SCHEMATIC PLAN

FRA-71-14.36

Ohio DOT Workspace
70171 West Interchange 6R
www.mscconsultants.com

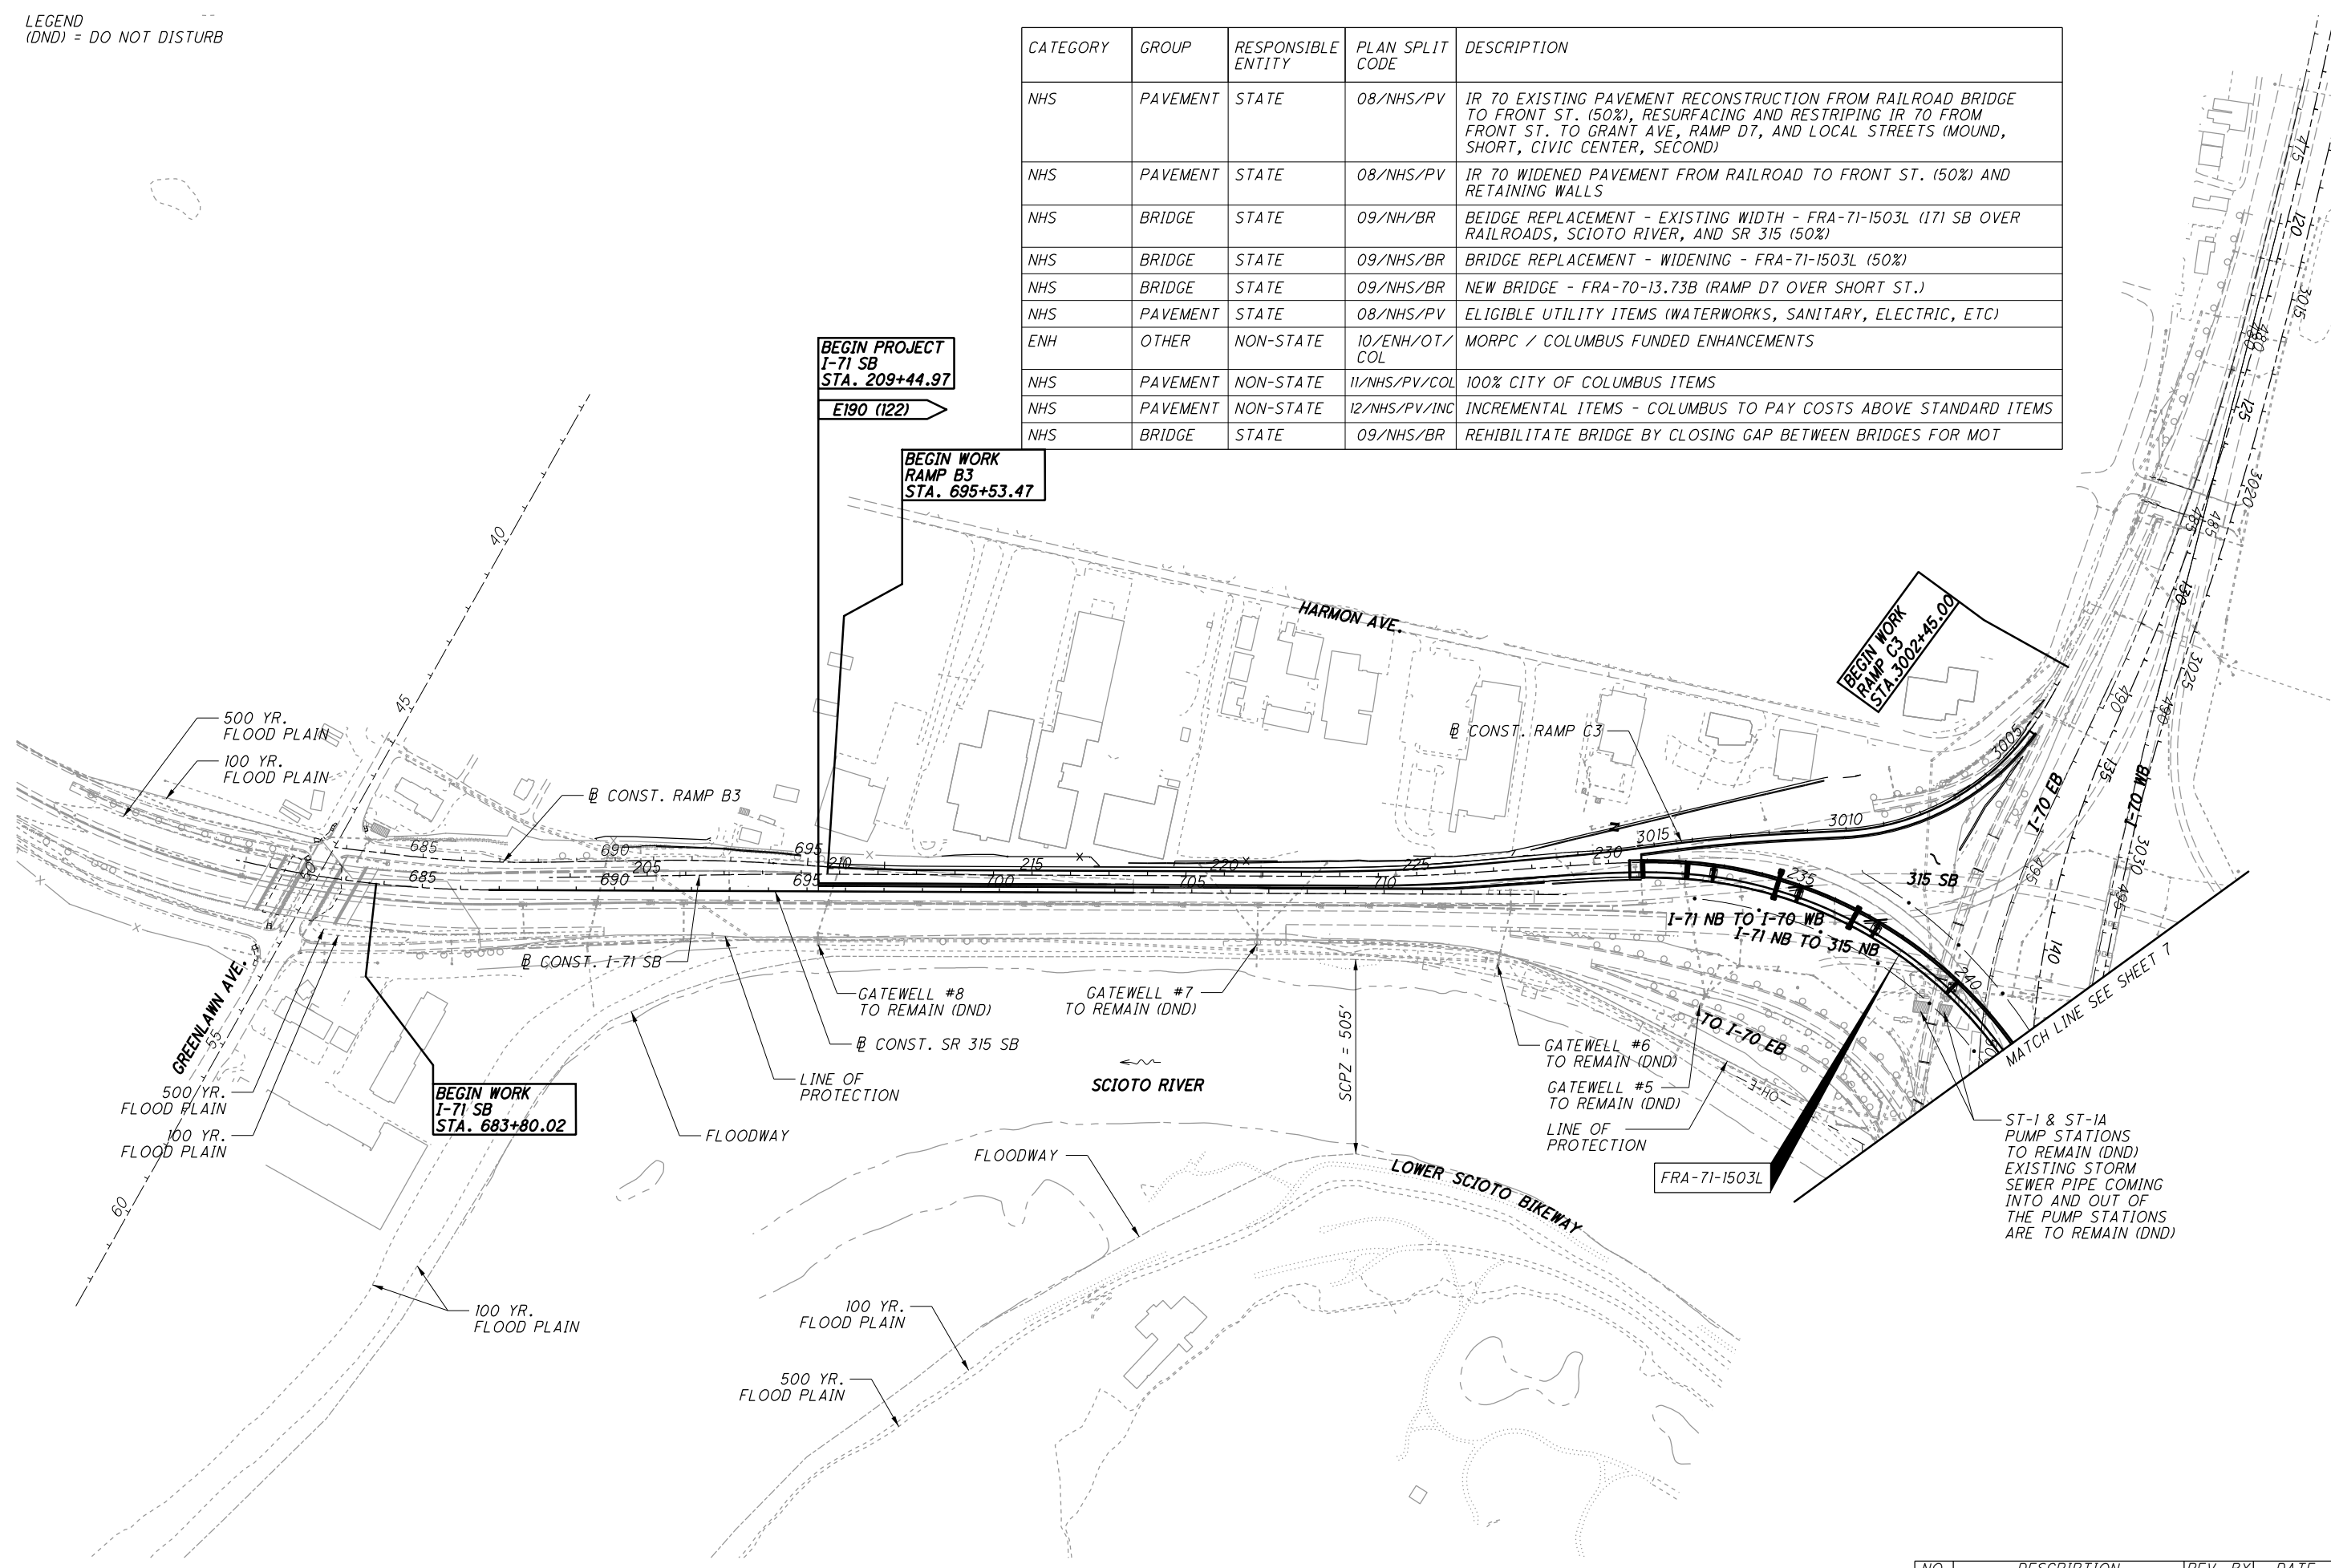
NO.	DESCRIPTION	REV. BY	DATE
1	REVISE PLAN SPLITS	TAZ	09/30/21
4	REVISE PLAN SPLITS	TAZ	11-29-2021

CALCULATED
 CHECKED
 MISC. DETAILS - BRICK CROSSWALK AND BRICK WALK
 FRA-71-14.36
 559
 1228
 ms consultants, inc.

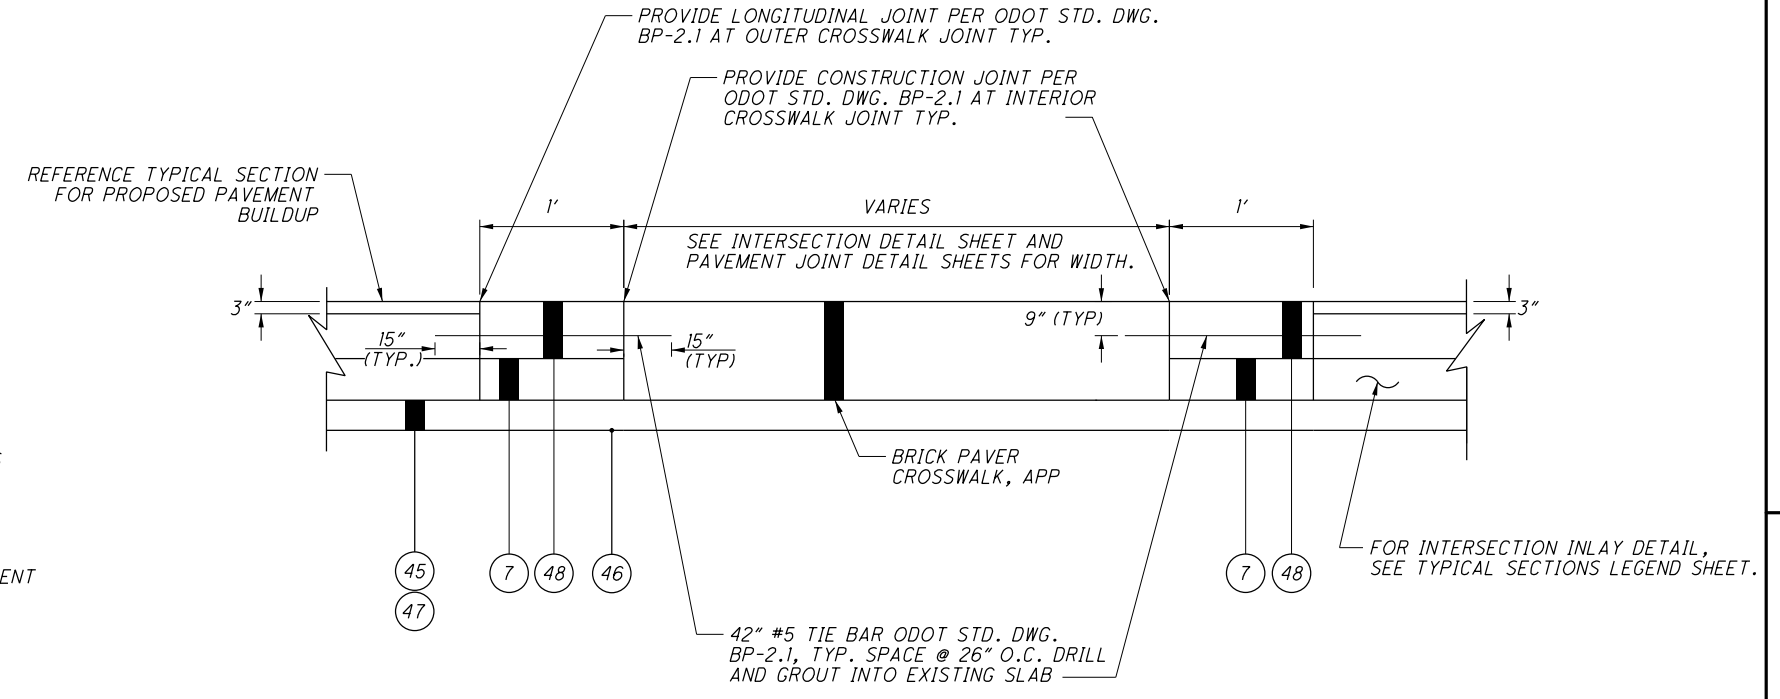
NO.	DESCRIPTION	REV. BY	DATE
4	Remove Conflicting Note	TAZ	11-24-2021

**SANITARY PLAN AND PROFILE
36" SANITARY LINE**

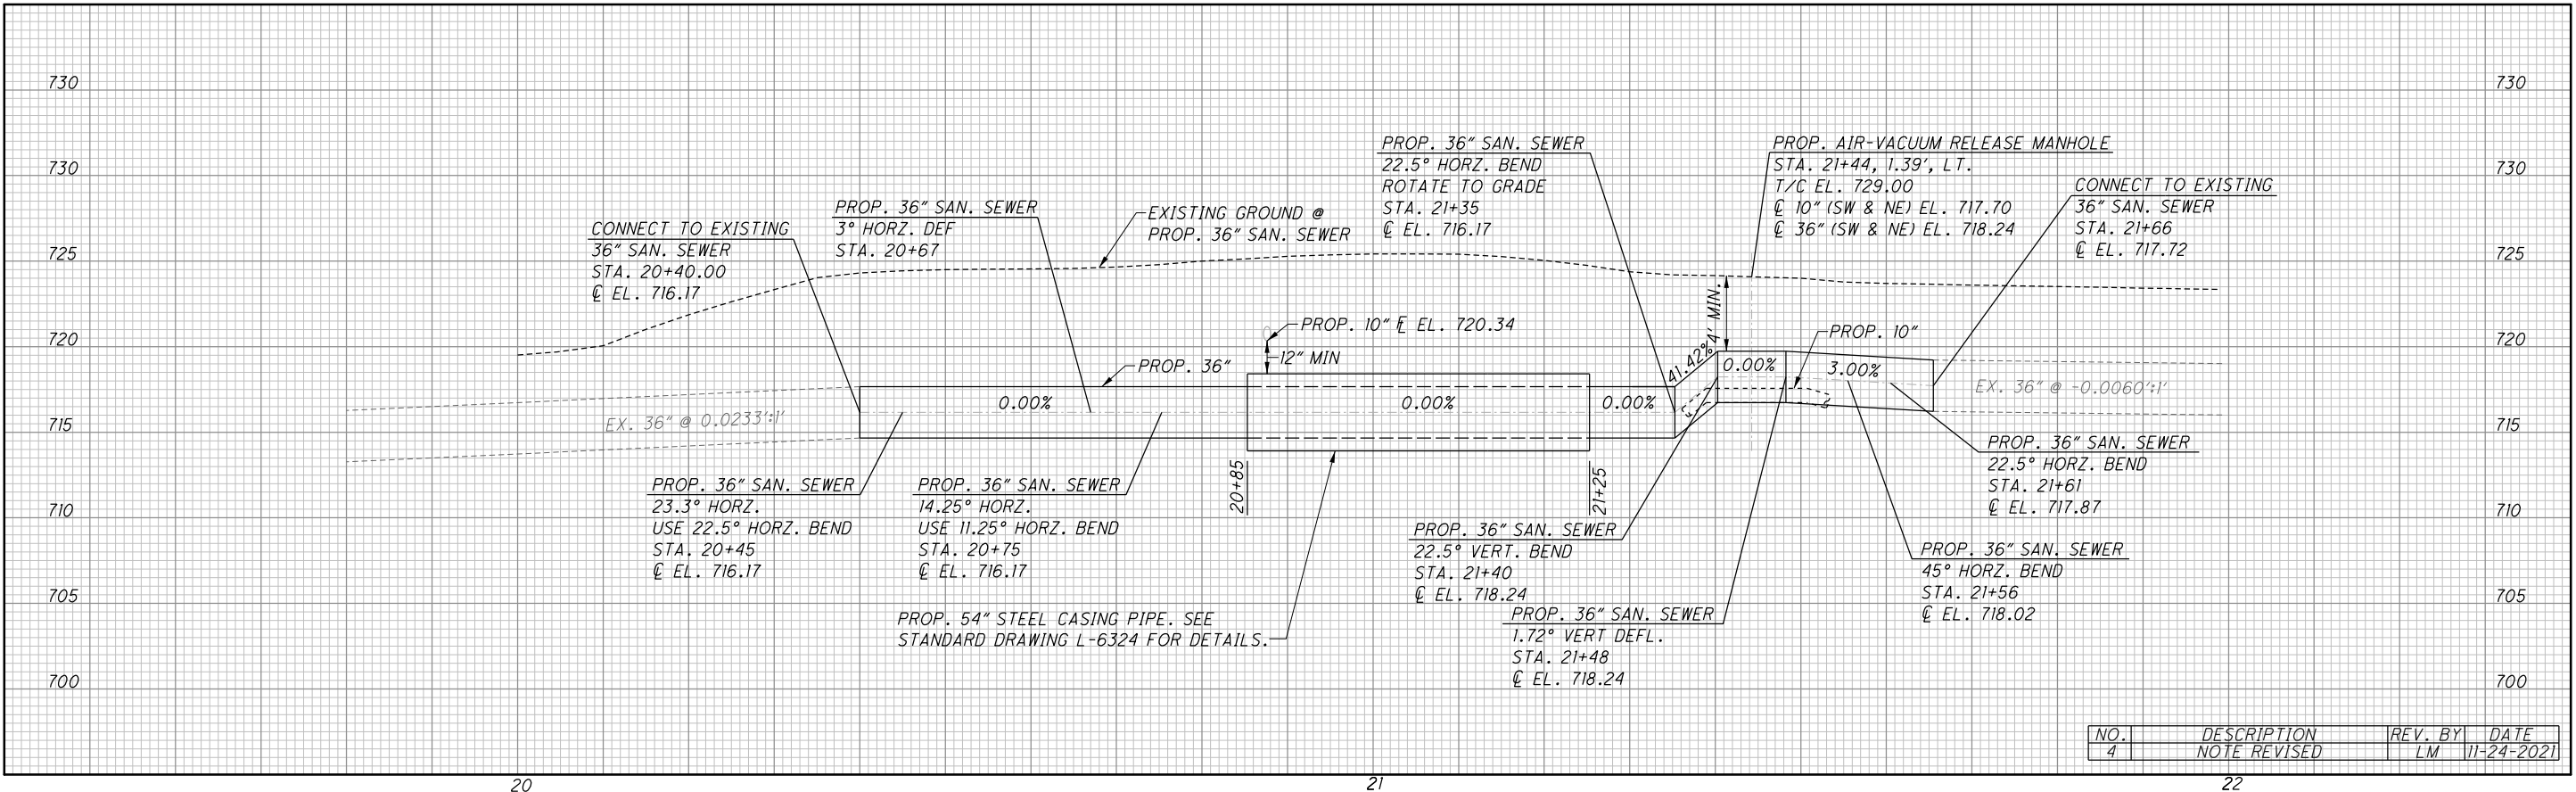
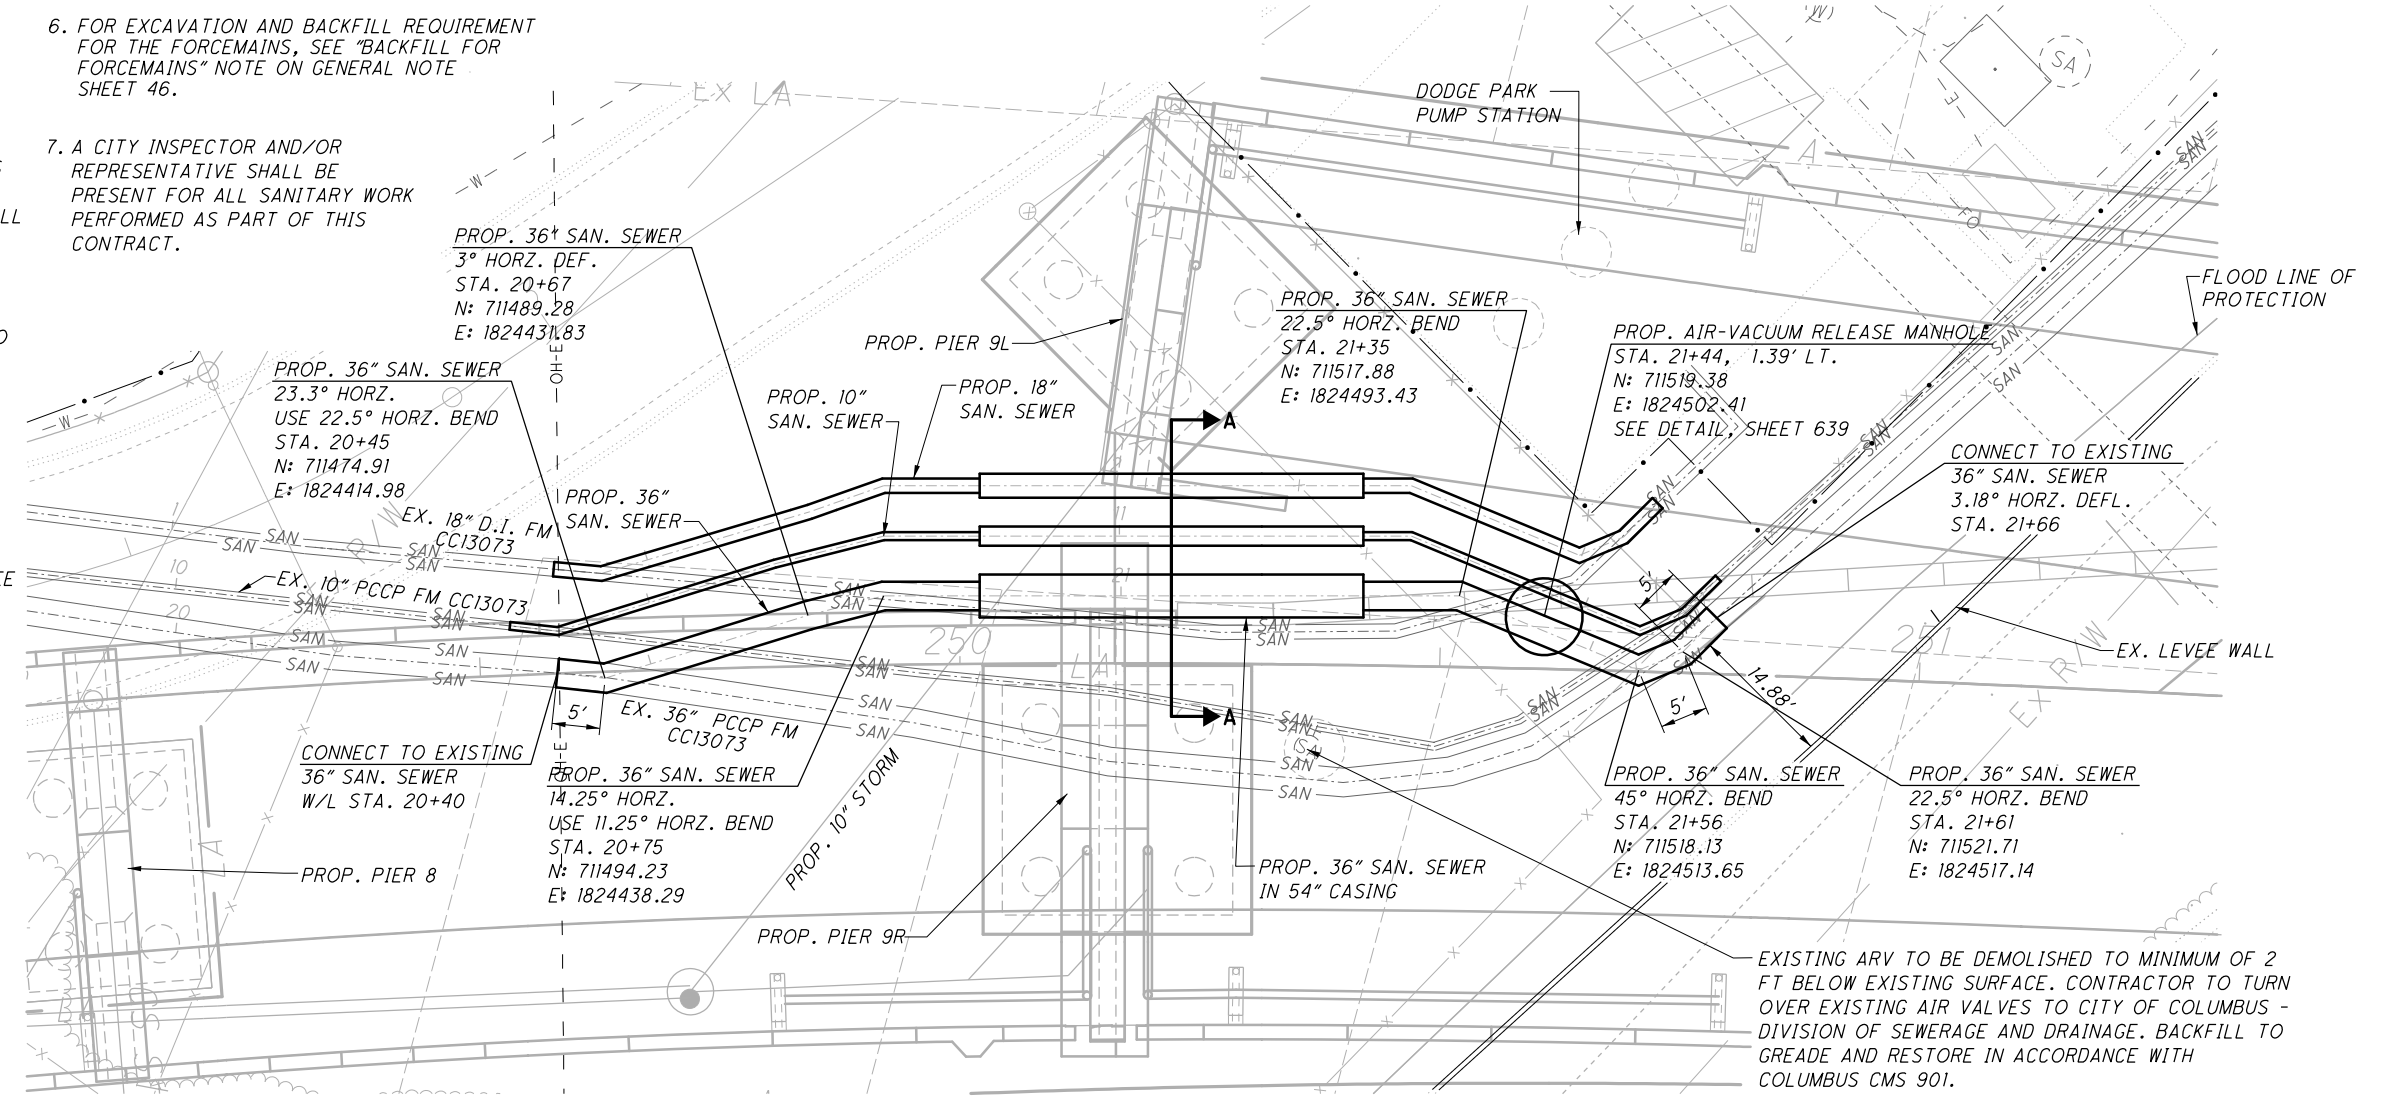
NO.	DESCRIPTION	REV. BY	DATE
4	NOTE REVISED	LM	11-24-2021

- FOR EXCAVATION AND BACKFILL REQUIREMENT FOR THE FORCEMAINS, SEE "BACKFILL FOR FORCEMAINS" NOTE ON GENERAL NOTE SHEET 46.
- A CITY INSPECTOR AND/OR REPRESENTATIVE SHALL BE PRESENT FOR ALL SANITARY WORK PERFORMED AS PART OF THIS CONTRACT.
